Special Meeting of Council
Tuesday, 14 May 2019

1.1 Planning Permit Application 18/0419 - 2 and 4 Geelong Road, 48-50 Bell Street and Lumley Close (Lot 1 on TP92118S), Torquay

The purpose of this report is to determine a position on Planning Permit Application 18/0419 - 2 and 4 Geelong Road, 48-50 Bell Street and Lumley Close (Lot 1 on TP92118S), Torquay.

Figure 3 – Proposed works in road reserve. Source: Application documents

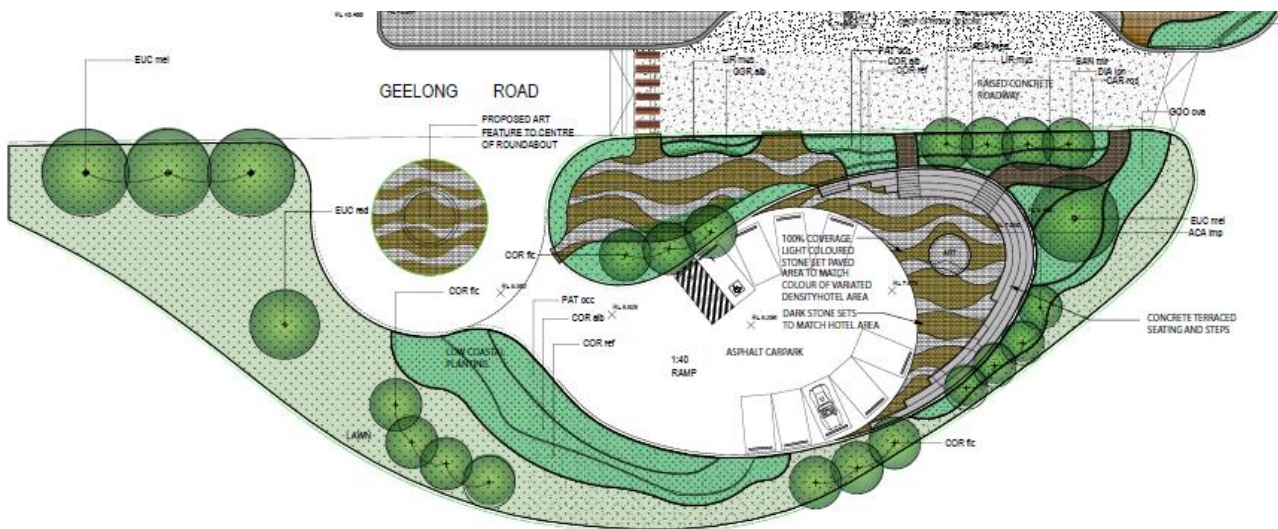
Nine car parking spaces are proposed, along with a 'Tourist Info Kiosk', extensive landscaping and a concrete terraced seating and steps arrangement. It appears that the works are designed to provide for additional car parking areas for the various uses on the land, along with a vehicle circulation space which would allow for guest drop off and pick up. The plaque currently located in the road reserve is proposed to be removed.

A new speed hump is proposed on Geelong Road, along with kerb and channel works and three new on street car parking spaces in front of the site on Geelong Road, which would result in the loss of the nature strip area and footpath currently located in the road reserve in front of the site. The remainder of the current nature strip area to the north of the site would be converted to a hard surface treatment.

No detail has been provided about the Tourist Info Kiosk, other than the planning report submitted with the application setting out that the works in the road reserve will include *an information hub for tourists visiting Torquay and embarking on a trip along the Great Ocean Road.*

Figure 6 – Building height over Lumley Close.

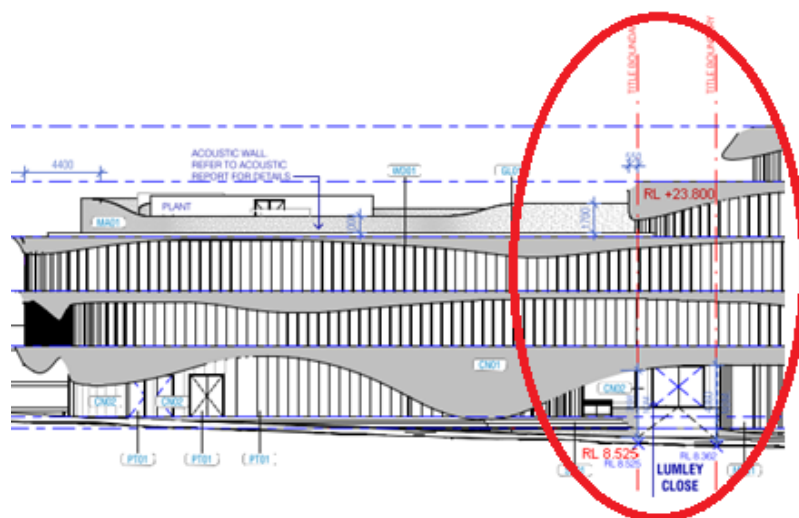
The bulk of development (including acoustic screens) in the General Residential Zone is less than 12 metres. An exception to this is the development located above Lumley Close. The north eastern end of Lumley Place is zoned General Residential Zone and the building height in this location is 15.275 metres and four storeys in height, as can be seen in the image below.

In addition, the development is effectively four storeys above the ground in the General Residential Zone. As the building is constructed over Lumley Close, there is no development at ground level, with three storeys above. The Planning Scheme defines storey as follows:

Figure 13 – Streetscape height comparison. Source: Application documents.

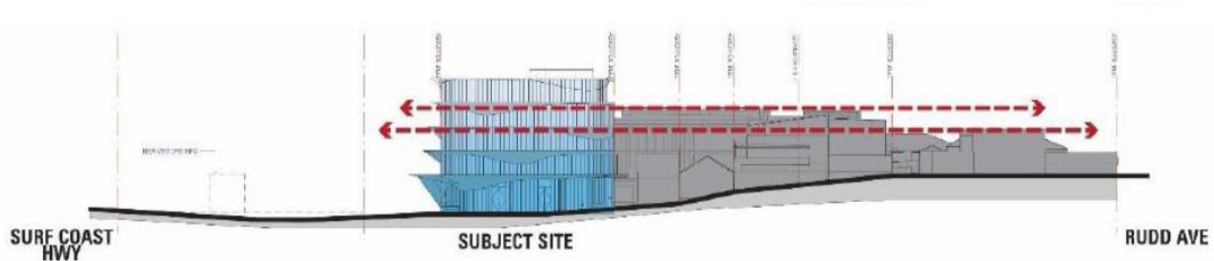
As already noted, the height of the development is not consistent with the streetscape. The design solution which results in the development being tiered toward Bell Street further emphasises the height of the development.

The streetscape height comparison diagram included with the application shows that the development is substantially higher than the development along Bell Street. As the land slopes to the west in front of the site, the scale of development is much higher than other development in the street. The flat comparison diagram included above does not acknowledge the siting and massing of the buildings which are located to the east.

Figure 15 – Roof plan showing projections into road reserve. Red line is title boundary. Source: Application documents

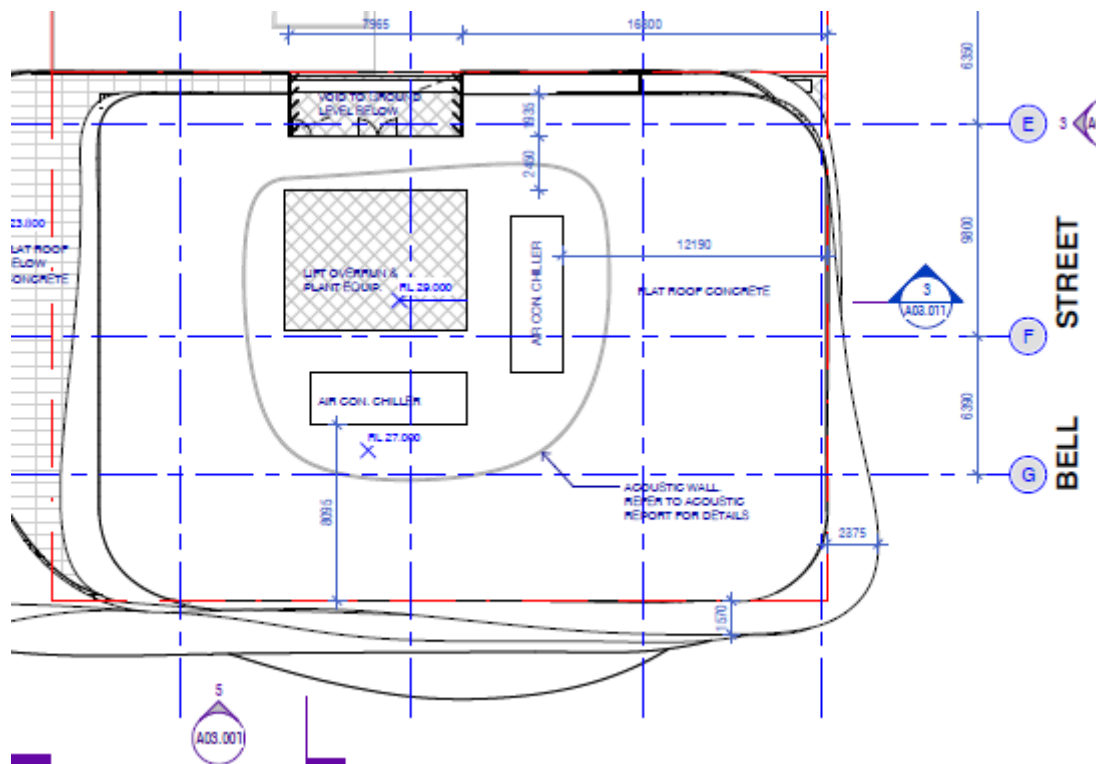
It is not readily apparent how the application would be modified to achieve the suggested condition given the extent of awning/ soffit in the road reserve and the siting of the various floors of the building.

Figure 16 – Proposed on street parking arrangements in Geelong Road. Source: Application documents

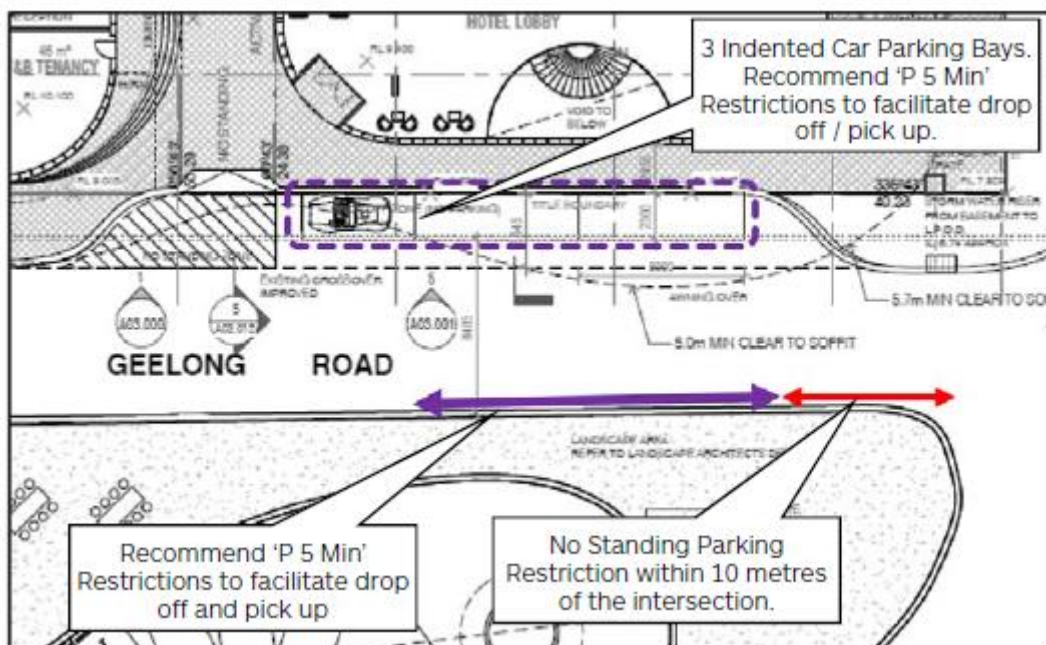
In addition to the on-site car parking proposed, it is intended that the public land in the road reserve in front of the site will be co-opted by the development, with the Traffic Impact Assessment recommending that the car parking spaces on Geelong Road are used as a drop off zone and restricted to P 5 Minute car parking restrictions.

Council's Engineers do not support the indented drop off zone, the restricted parking and the car parking provided around the roundabout in the road reserve. Council's Engineers have noted that car parking demand in this area is at capacity in the peak season and longer term parking spaces are utilised. Reducing the availability of on street parking in this area is not supported, nor is removing the existing footpath within the Geelong Road road reserve, as well as limiting the potential for any landscaping to be undertaken in the road reserve on Geelong Road. This is a ground of refusal.

Figure 17 – Plan showing new treatment of Lumley Close and proposed gate. Source: Application documents

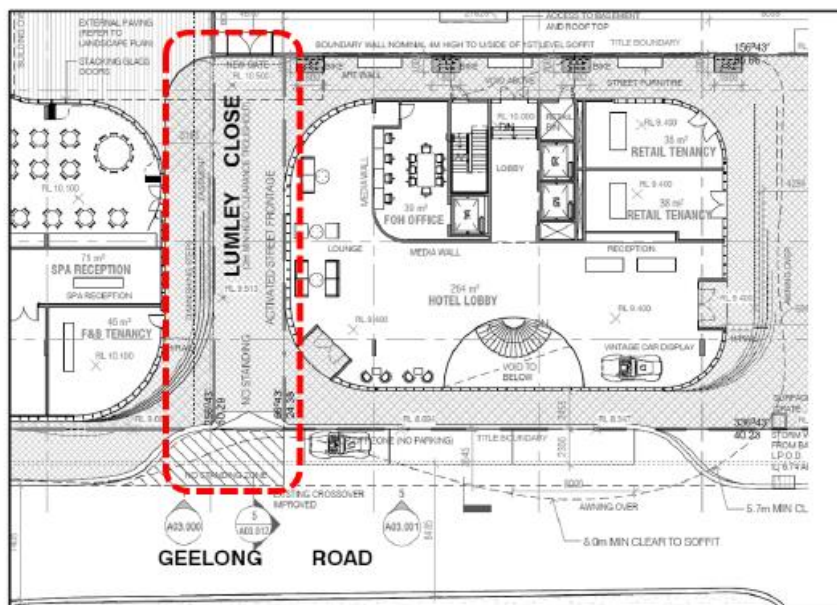
The application is silent on how ongoing access to these properties would be managed. Given the substantial excavation works proposed, it is not clear how access will continue to be available during the construction phase. This is a ground of refusal. A further part of this ground of refusal is that an appropriate clearance has not been achieved to allow vehicles to access Lumley Close through the site, impacting on the ability for the servicing of the neighbouring properties by trucks. It is also proposed to gate Lumley Close as seen in the image below. It is not clear how gating of this laneway would allow for convenient access to the rear of these properties for vehicles, including service vehicles.
